# U DISTRICT SAFEWAY REDEVELOPMENT

DESIGN RECOMMENDATION  
RECORD #3033508-LU  
APRIL 10, 2020

ITEMIZED RESPONSE TO EDG 3

SDG|DC2. Reduced Perceived Mass

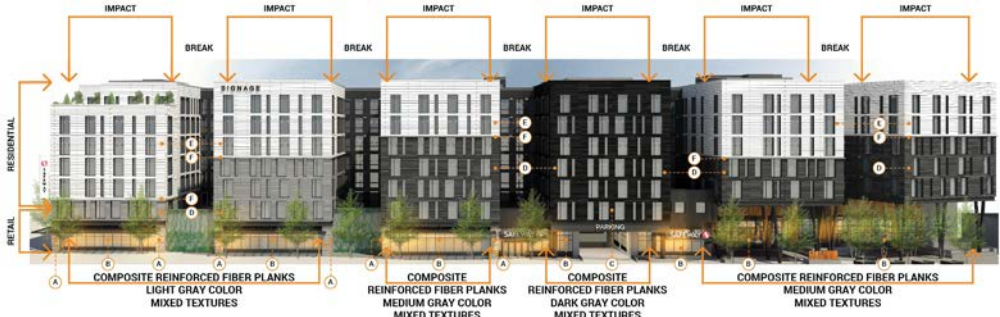
**Board Comments:**  
*The Board agreed that the building design currently does not use the long building length along Brooklyn Avenue as an asset. Guidance was provided to improve this through the expression of the individual bays along Brooklyn Avenue as unique parts of the overall design while utilizing secondary design elements to create rhythm along the street frontage (DC2-A-2. Reducing Perceived Mass, DC2-C-2. Dual Purpose Elements, DC2-E-1. Form and Function).*

**Response:**  
The bays are now individually expressed through the progression of light and dark panels taking the length of Brooklyn Ave as an asset in giving rise to a rhythmic pattern along the street frontage, with the deep courtyards creating a pause and a break along the length of the building. Overall, the retail frontage will be mostly contiguous with the ins and outs of the facade giving each bay its place in the rhythm.

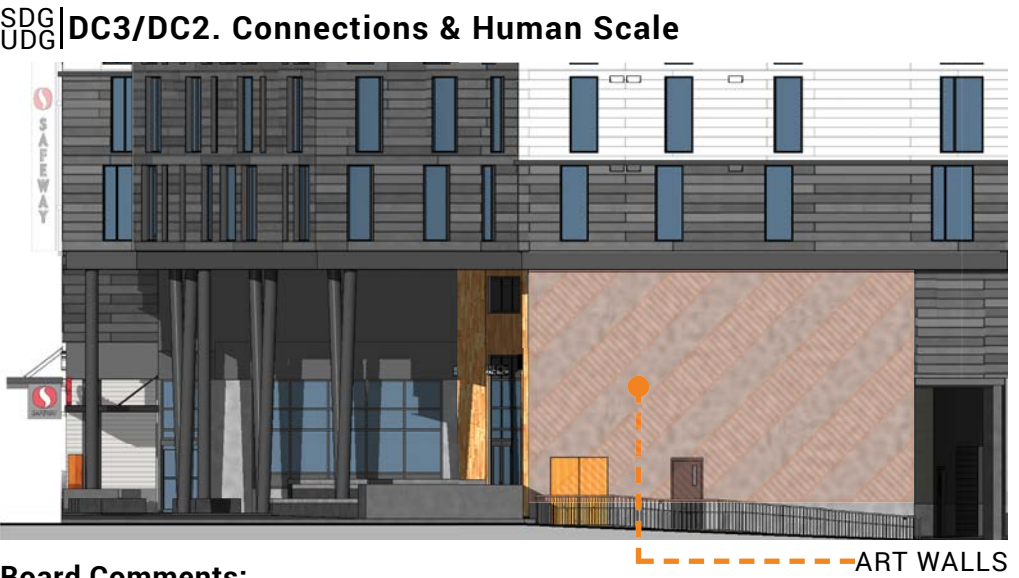
*The Board further recommended treatment of the northeast corner with a muted corner expression through secondary architectural features like the grouping of windows. Additionally, the Board recommended wrapping the alley artwork to the north facade to supplement the expression of the residential entry (University PL1-2-E. Signage & Wayfinding, PL3-A-2. Ensemble of Elements).*

The northeast corner has been muted with secondary architectural features and the continuation of the rhythm of materials and windows from all the other sides. Art elements will continue from the alley corner to the north facade and will provide interest along 50th St.

SMC 23.48.635.A - Building Width - EDG 3 Comment

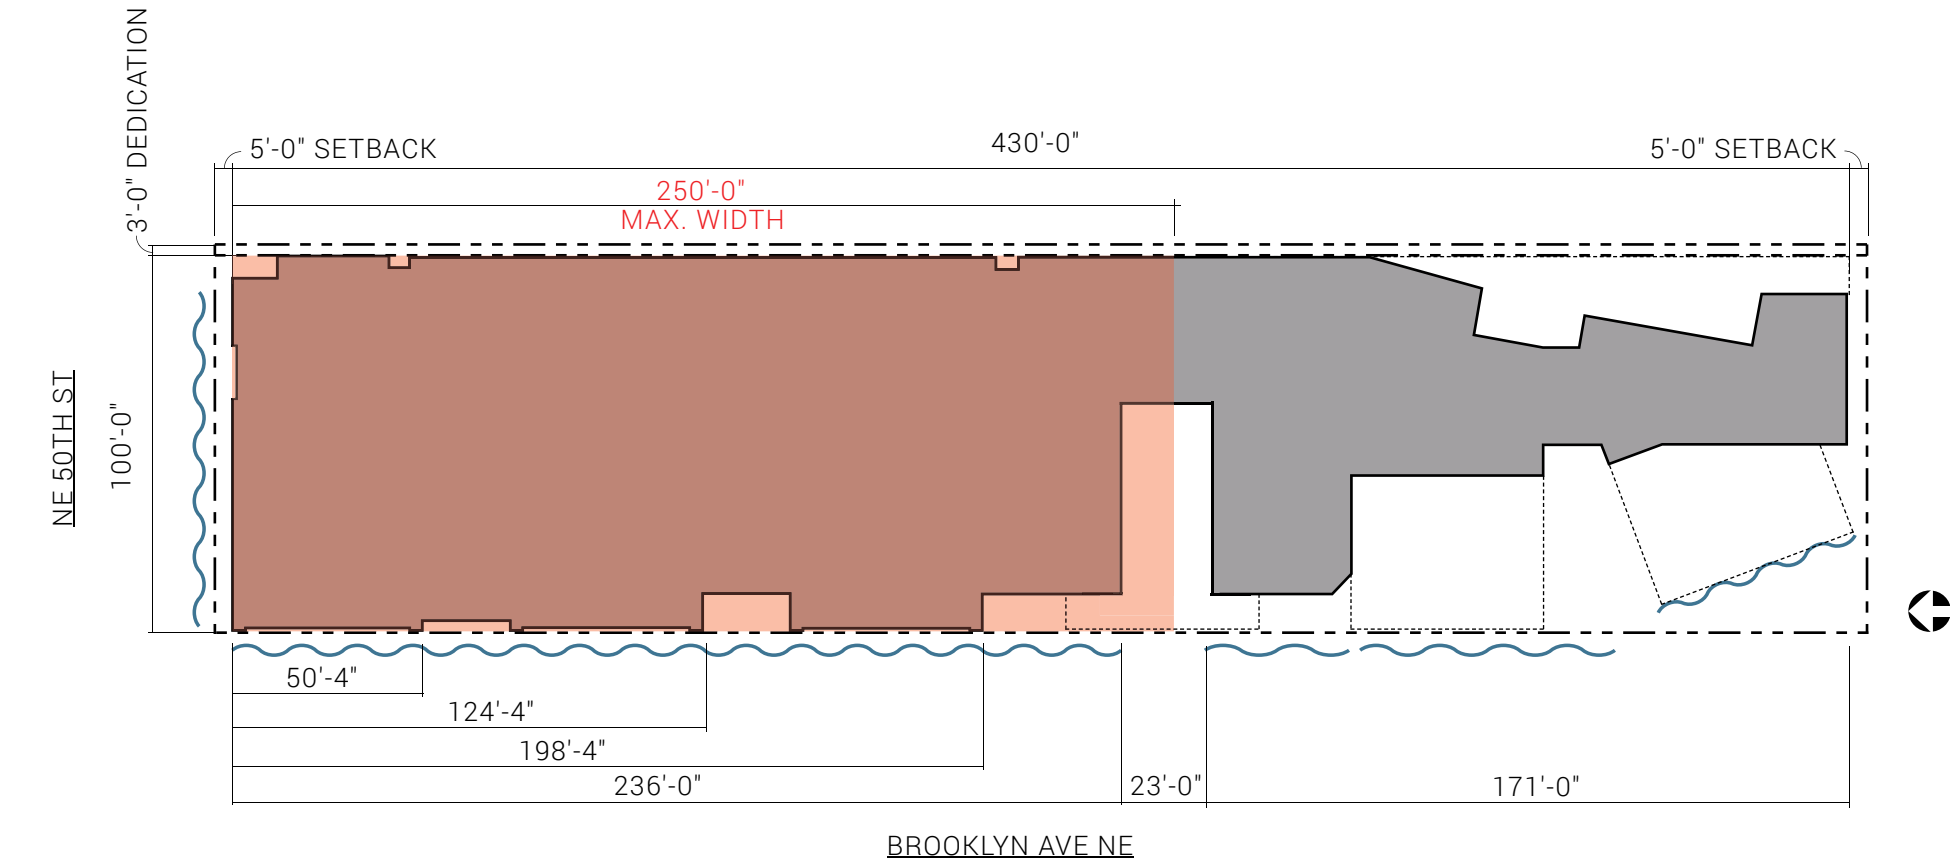
The Board agreed unanimously that they were not yet supportive of this departure, stating that it could not be supported until the guidance described above was fully addressed. Similar to the First and Second EDG meetings, the Board emphasized that the guidance related to building massing and materials will be critical in recommending any approval of a departure for façade length. At the Third EDG meeting, the Board added that the massing and use of materials should illustrate a design concept where the long façade becomes an asset to the site, not a repetition of the same massing pieces along Brooklyn Avenue. Board guidance included recommendations for unique expression of individual bays and creating rhythm throughout the façade design to stitch together the separate massing pieces. (University DC3-1-a. Arrangement, DC2-1 Massing & Reducing Bulk and Scale)

While the overall building length remains at 430', the updated Preferred Scheme reduced the length of the street-level building façade along the sidewalk edge of Brooklyn Ave to 198'-4" feet with two additional breaks at two locations before the Safeway entrance which then continues to the public accessible open space. The scheme shows increased detail for EDG2, with depth and materials detailing the massing changes requested by the Board's direction. With the development of the design, the departure is again requested to be considered with the following clarifications:

SMC 23.48.650.B.2 - Required Open Space - EDG 3 Comment

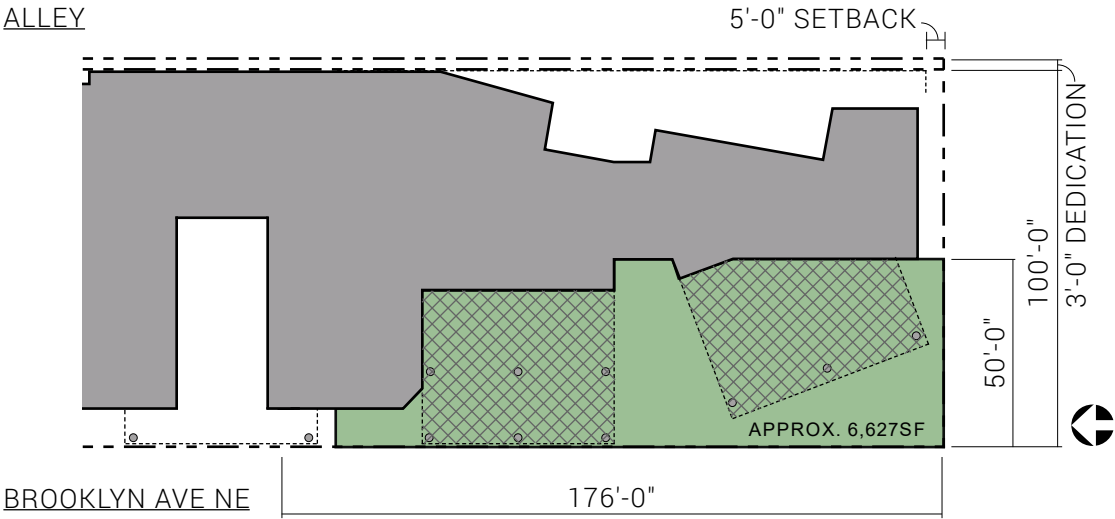
A majority of the Board indicated they were generally supportive of the requested departure because of the improvements to the design in response to the guidance from the Second EDG meeting. The Board cited the improved legibility of the open space for public use, the additional covering height, and the addition of unique furnishing as improvements that allow the departure for additional covered open space to be appropriate. The Board identified inconsistencies in the packet related to the intent for exterior doors along the north side of the open spaces, and added that the presence of doors for access to the adjacent commercial space to the north was necessary for the activation of the open space. (DC2-3-b. Layout, DC3 Open Space Concept, University DC3-1-a. Arrangement)

Per Table A, the minimum open space area required to be open to the sky is 60% (3,976 square feet). The proposed public open space is 39.7% open to the sky (2,630 square feet), a reduction of 19%. The proposed reduction in area open to the sky has been designed to provide the public with an outdoor covered area of 3,997 sf that provides a protected transition between the outdoor open space and indoor building programming, brings focus to the neighborhood park via a pronounced and expanded landscape plaza feature, and provides overhead weather protection allowing the public to enjoy all of the amenity space year-round.
